UNITED STATES
NUCLEAR REGULATORY COMMISSION
WASHINGTON, D. C. 20555

SAFETY EVALUATION BY THE OFFICE OF NUCLEAR REACTOR REGULATION
RELATING TO LIQUEFACTION POTENTIAL AT THE LA CROSSE SITE
DAIRYLAND POWER COOPERATIVE
DOCKET NO. 50-409

Figure 5. Free Field

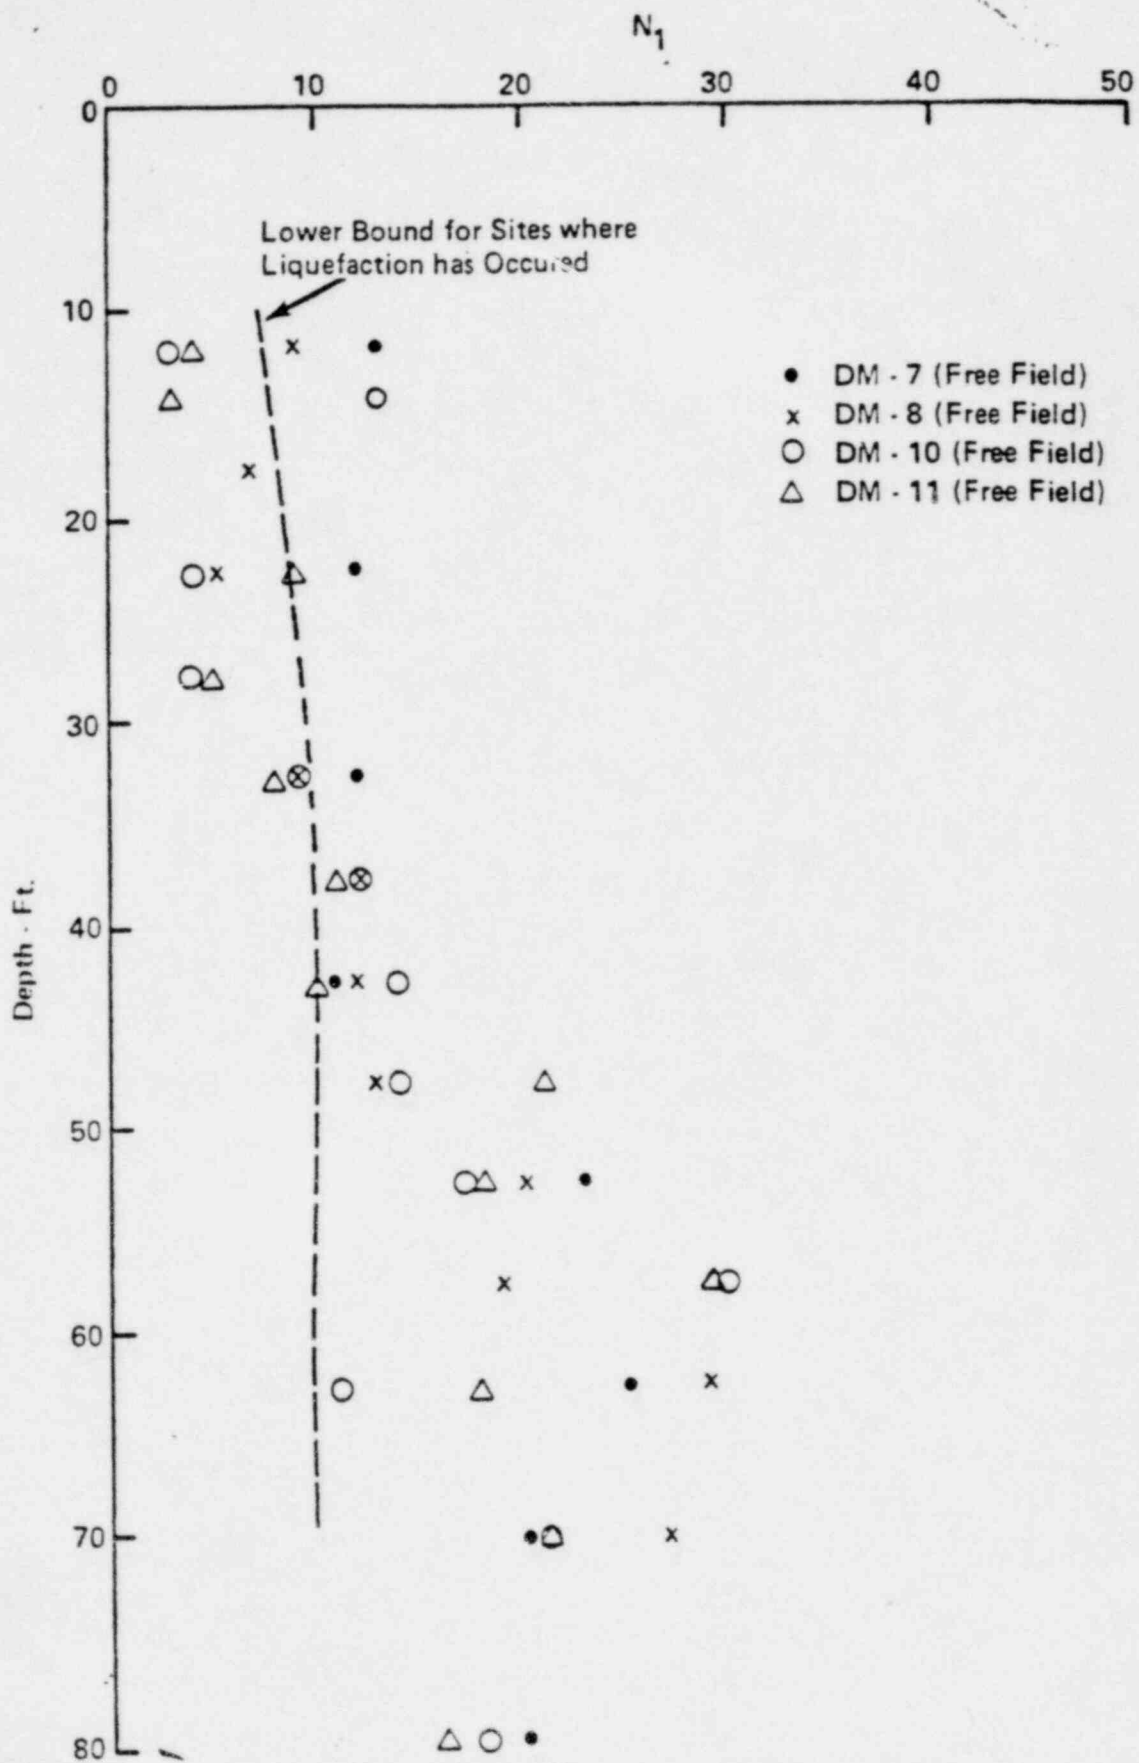
The degree of improvement in foundation support under pile supported structures can be seen in a plot of the variation of penetration resistance with depth (see Figure 5 thru 8). Figure 5 shows the results of borings DM-7, 8, 10 and 11. These borings are located in the free field in areas not influenced by past pile driving operations. Penetration resistance has been corrected for overburden pressure and Figure 5 data shows that liquefaction potential does exist to a depth of 35 feet in the free field when compared with the empirical approach for the lower bound at sites where liquefaction has occurred. This data obtained in the free field is considered applicable to the service water line which is buried in the hydraulic fill and the crib house which is located on the river bank. The results for the Turbine Building and stack are shown on Figures 6 and 7, respectively. These results clearly show that the piles produced an improved condition over earlier free-field subsurface conditions and indicate a low liquefaction potential for the turbine and reactor buildings. The improvement from free field conditions to conditions for widely spaced piles under the turbine building and densely spaced piles under the stack foundation is summarized on Figure 8.

Figure 6 Turbine Building

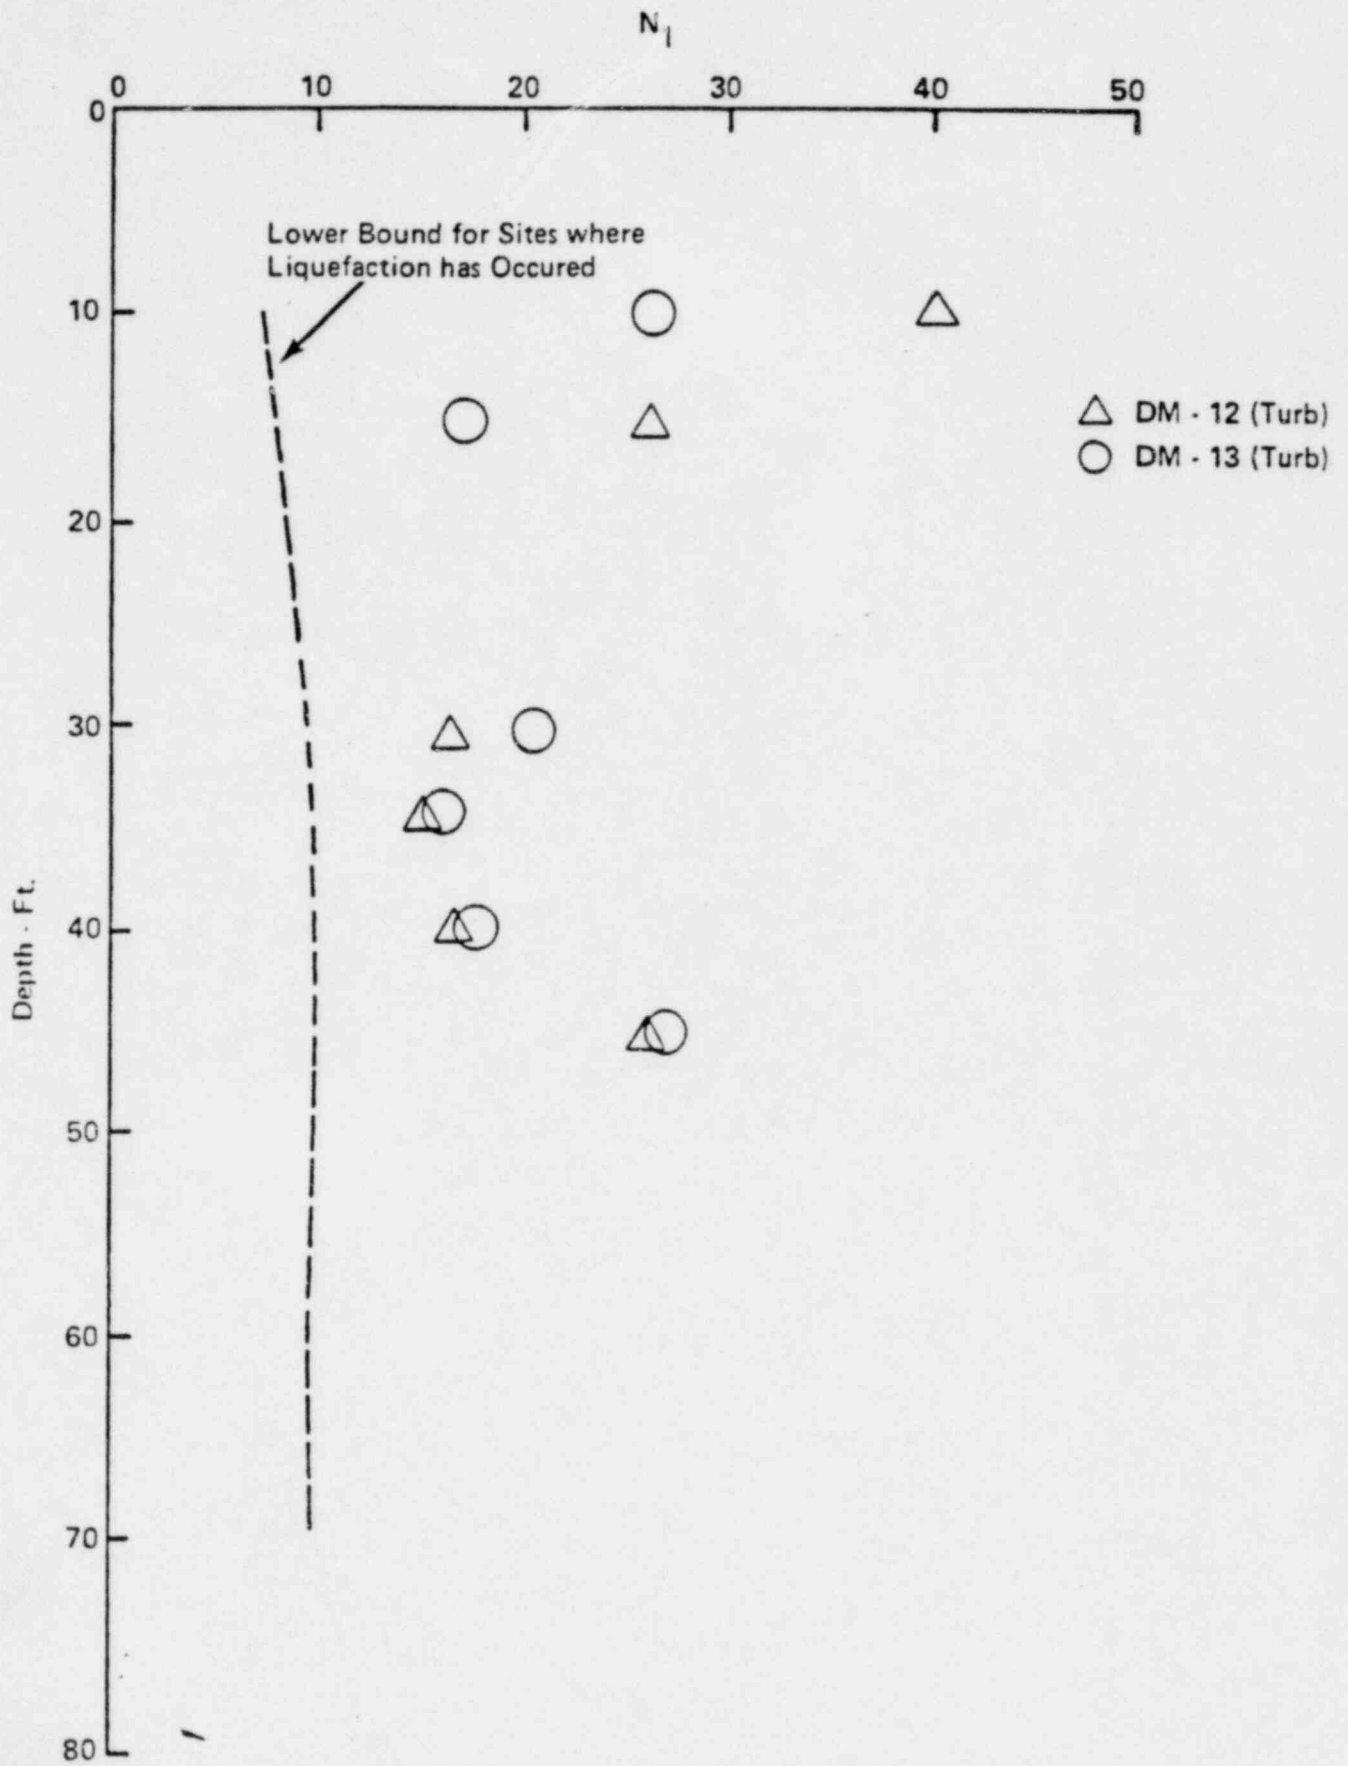
The documentation and quantification required to assess the increase in density in the soils under the pile supported turbine, containment and stack foundations has been provided in the recent Dames & Moore reports. The July 25, 1980 Dames & Moore report includes four recent test borings beneath plant structures which clearly indicate an increased density below these pile supported structures. Specifically borings DM-12 and DM-13 taken in the northwest corner of the turbine

building show a range in Standard Penetration Tests (SPT) hammer blow values taken in clean sands below the water table from 12 to 34 per foot of depth. This is a significant improvement over the SPT results from the free field boring (DM-7, 8, 10 and 11) which ranged from 2 to 17 blows per foot over the same depth. Test borings (DM-14 and DM-15) drilled under the stack foundation indicate an even larger increase in soil density. The SPT values under the stack, which has a much closer pile spacing, range from 23 to more than 50. Based on our review of the site foundation conditions, the borings under the turbine and stack foundations are considered representative for other adjacent structures that are pile supported, including for example the reactor containment building.

Upon reviewing the recent boring logs and data presented by Dairyland, we and our consultant, the Corps of Engineers, now conclude that the material under the existing turbine building and the reactor containment is adequately safe against liquefaction effects for an earthquake up to a Magnitude 5.5 with a peak ground acceleration of 0.12g. We now conclude that mitigative measures to increase the margin of safety against liquefaction for these structures are not needed. Although liquefaction is of concern for the crib house and underground piping, a site dewatering system is unnecessary to resolve this concern.
